CITY OF ARLINGTON PRAIRIE CREEK DRAINAGE IMPROVEMENTS PHASE 2A CONSTRUCTION - PROJECT NO. P02.371

AS BUILT

SHEET
C-4
 6 of 15

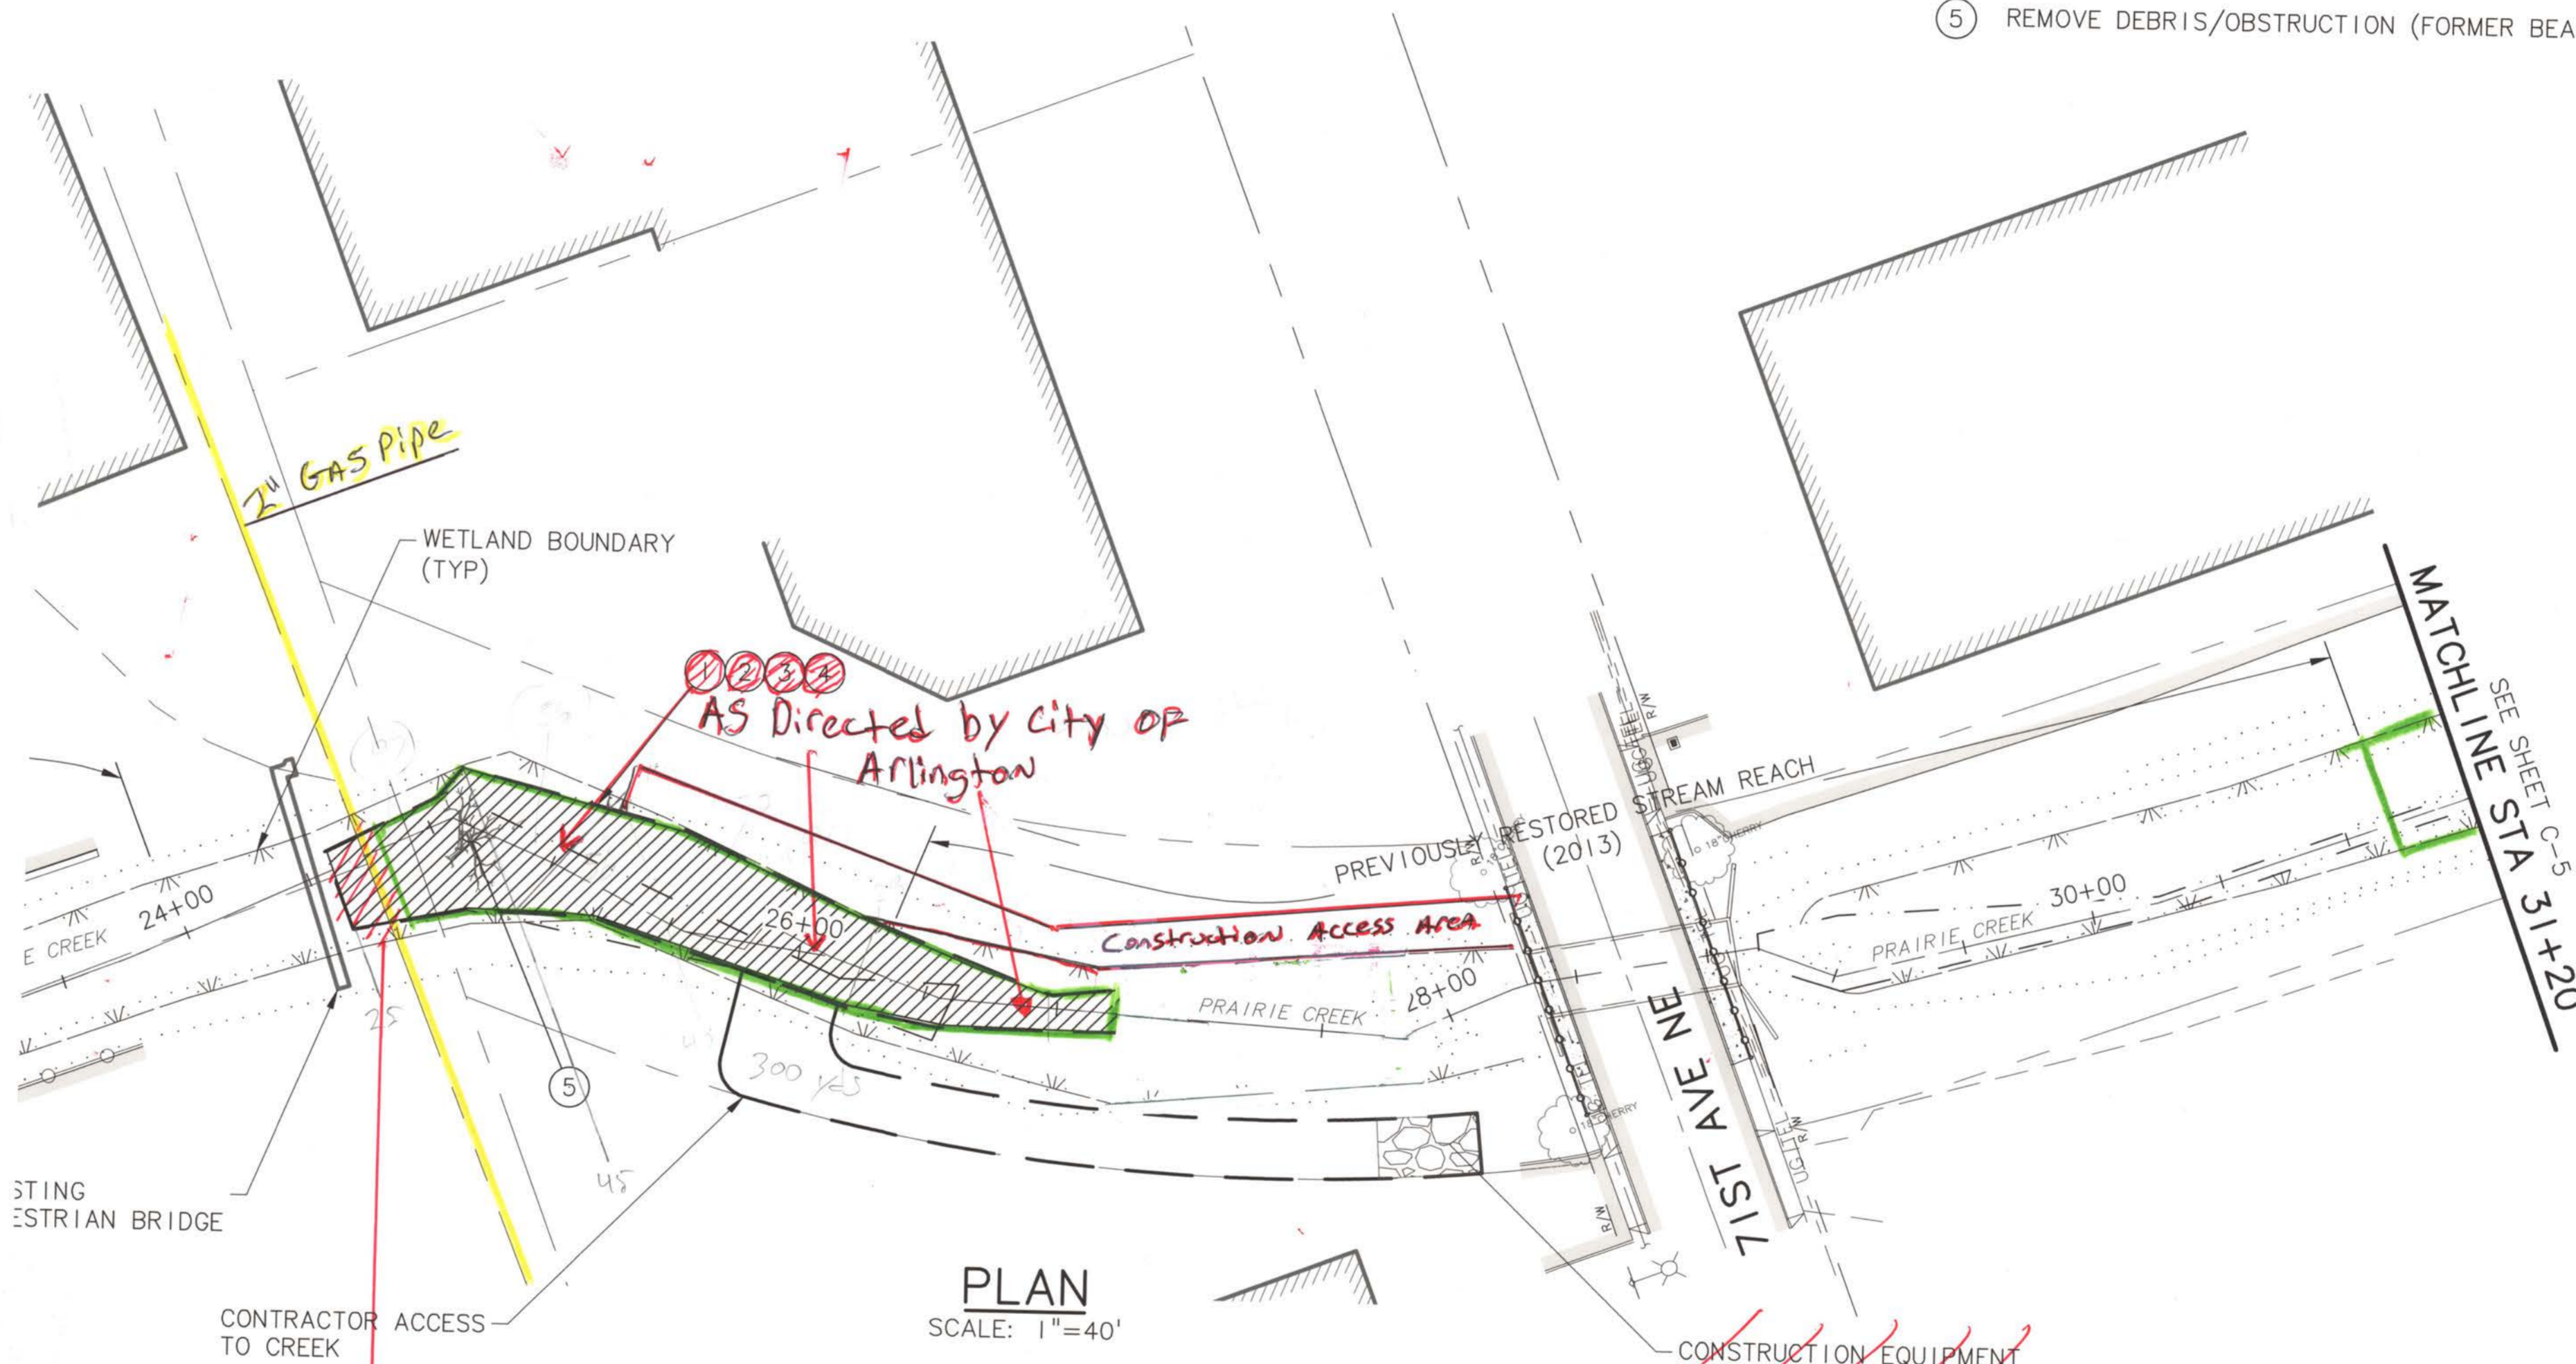
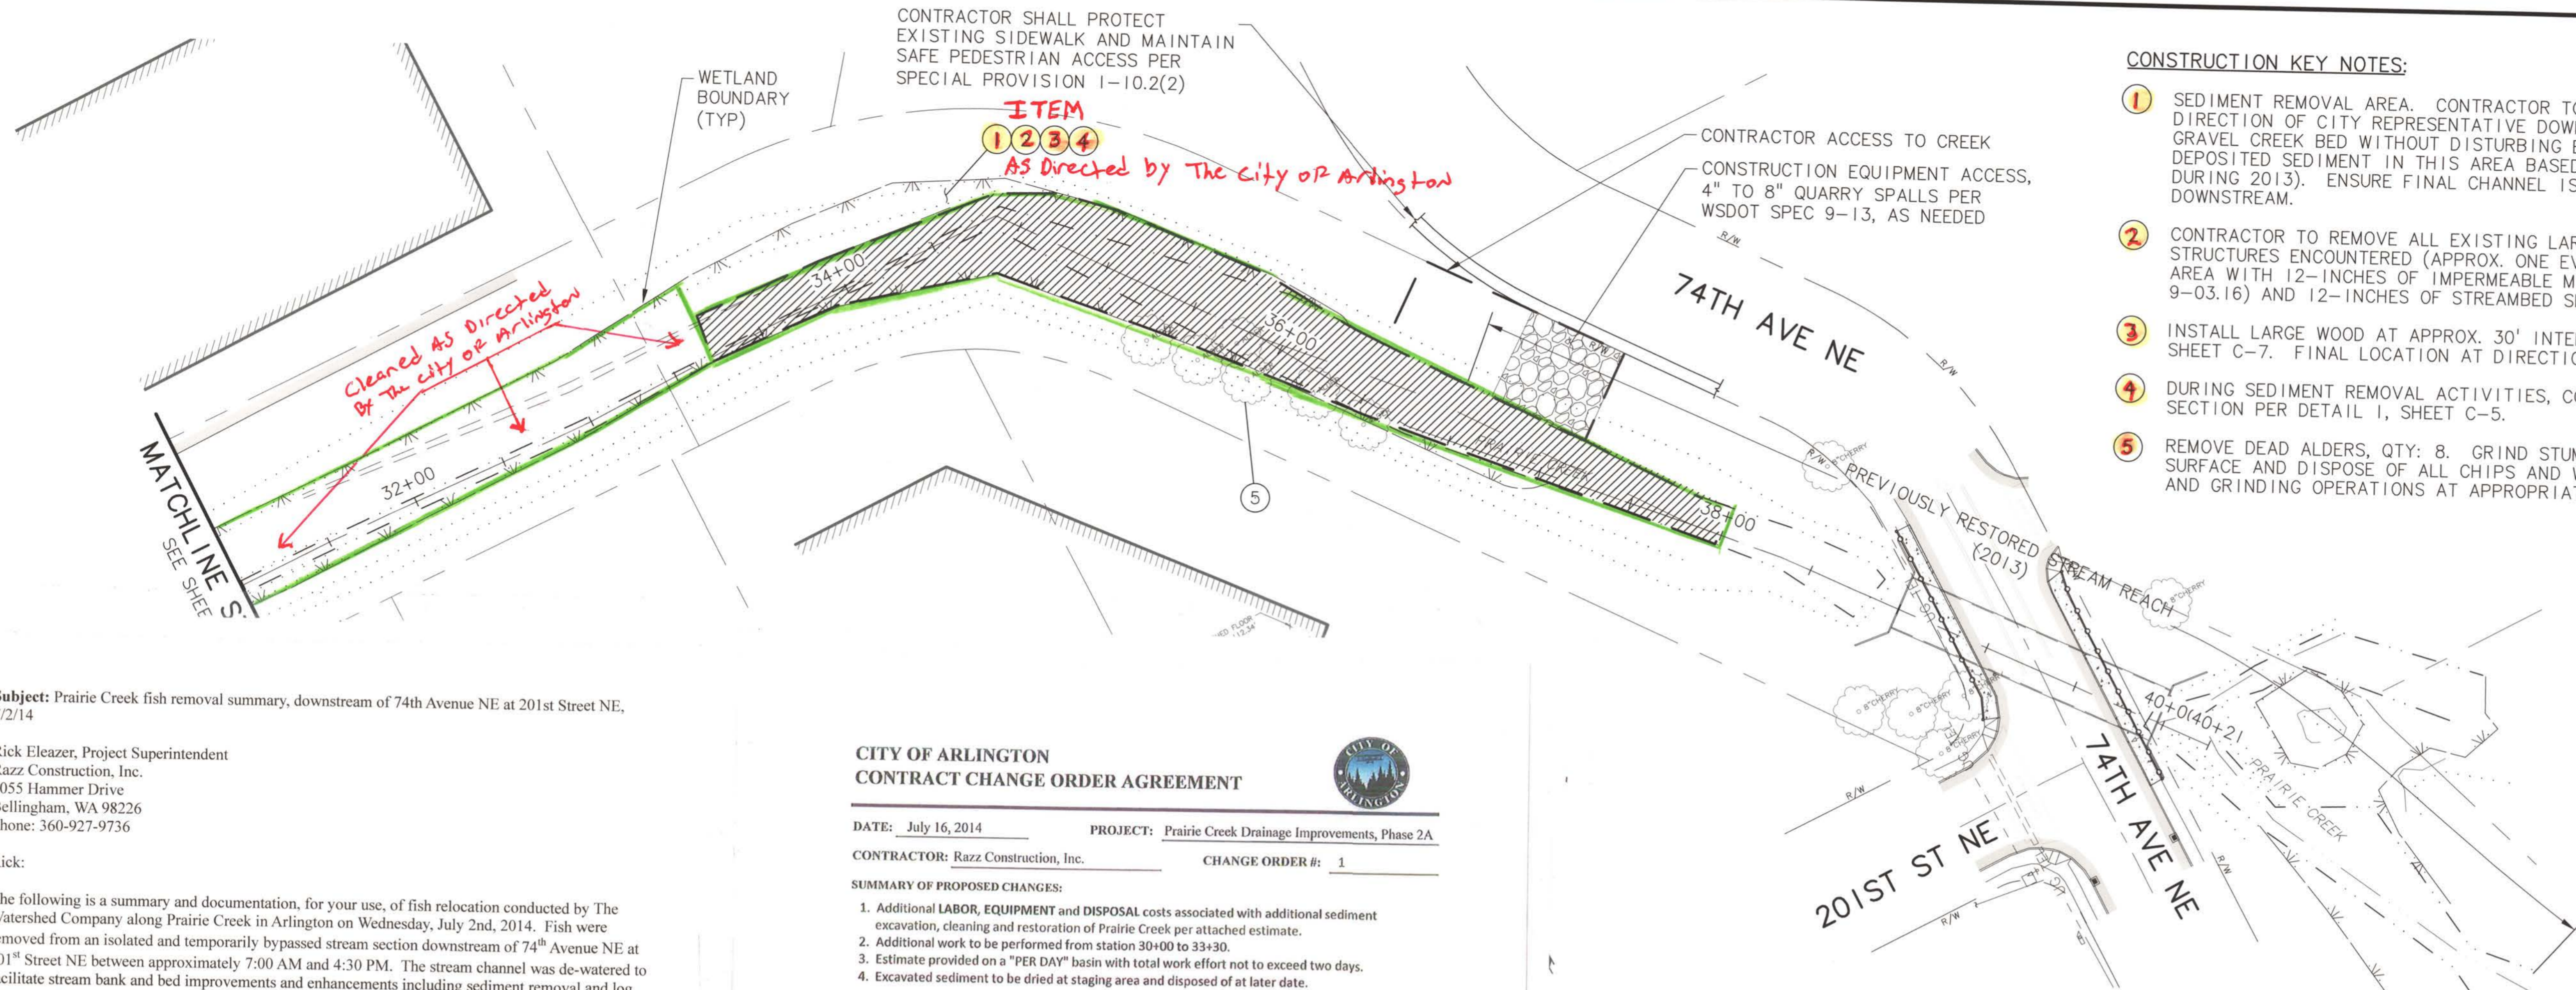
WAS to be by the City of Arlington
 To leave this area alone due
 To existing 2" Gas main.

WATER LINE RELOCATION DETAIL

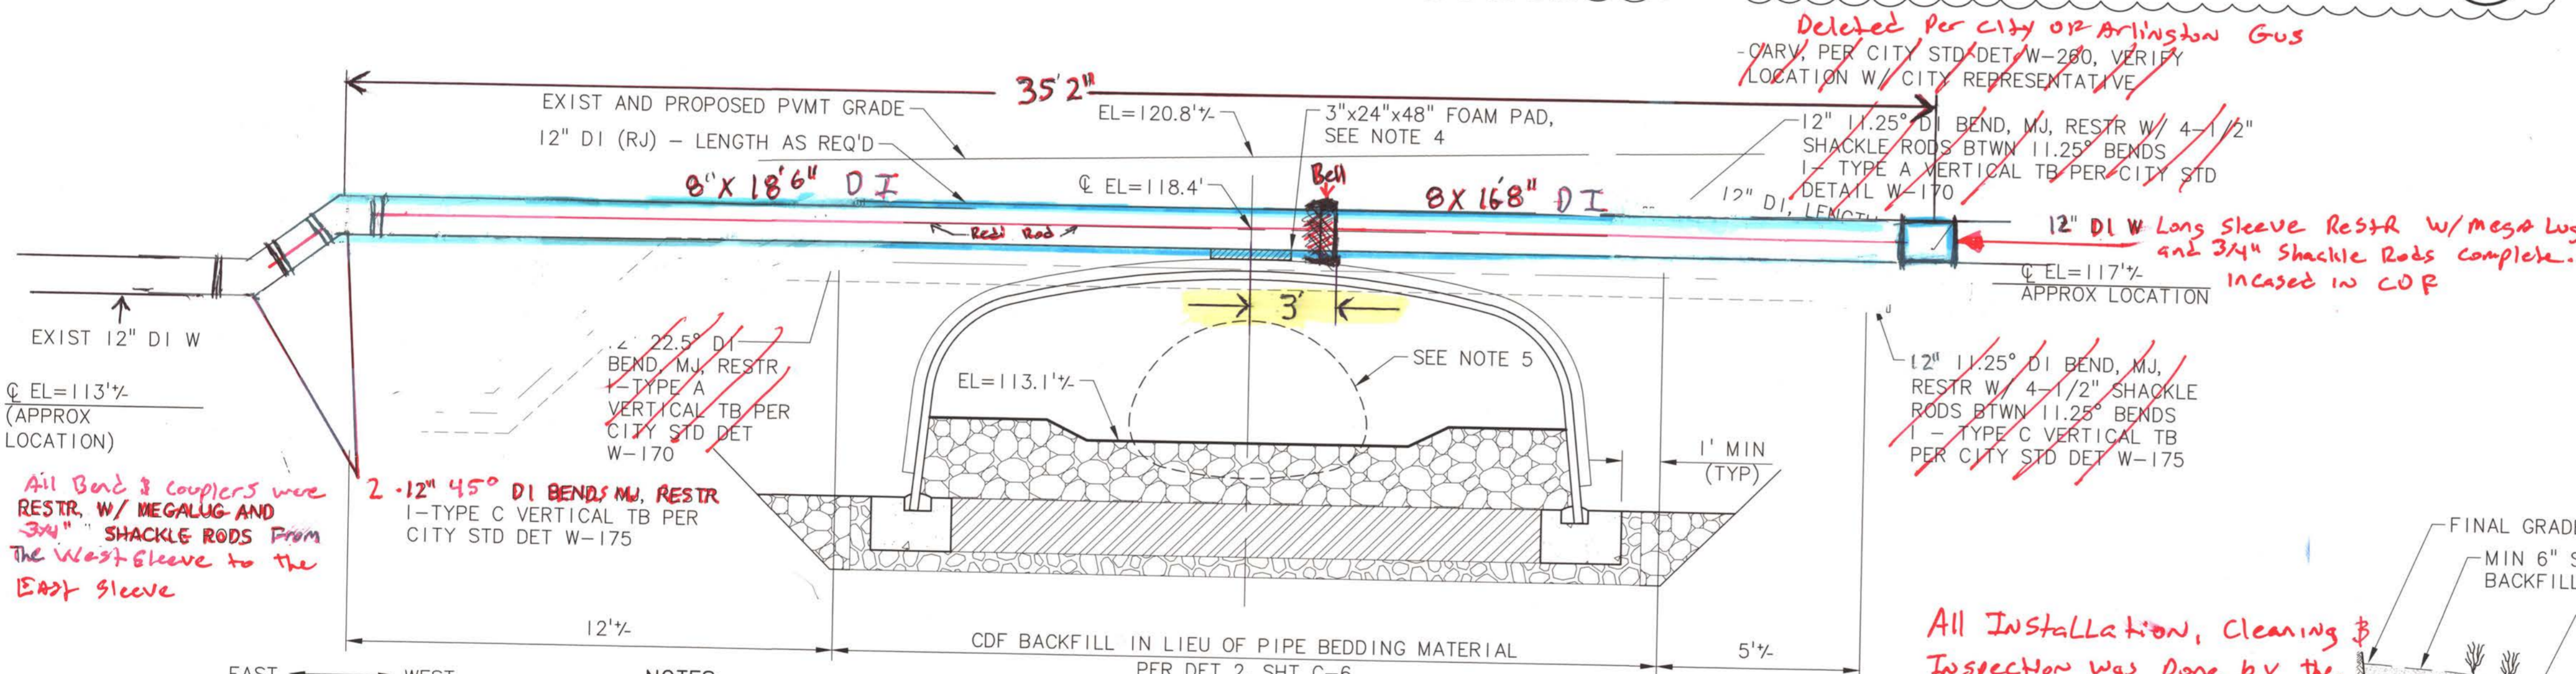
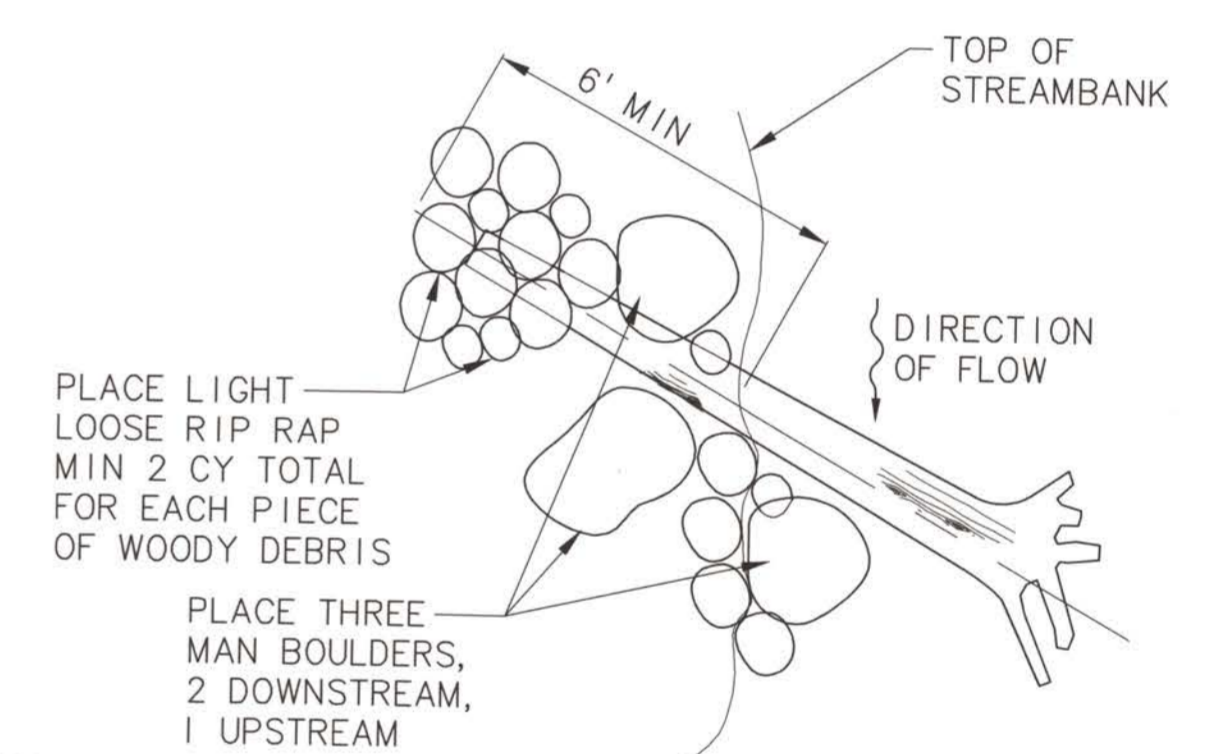
Deleted Per City OR Arlington Gus
 - OARV, PER CITY STD DET W-280, VERIFY LOCATION W/ CITY REPRESENTATIVE

12" DI W Long Sleeve Restr w/ megalug and 3/4" Shackle Rods complete. Incased in COP

All Installation, Cleaning & Inspection was Done by the City OR Arlington. Gus OR the water Dept.
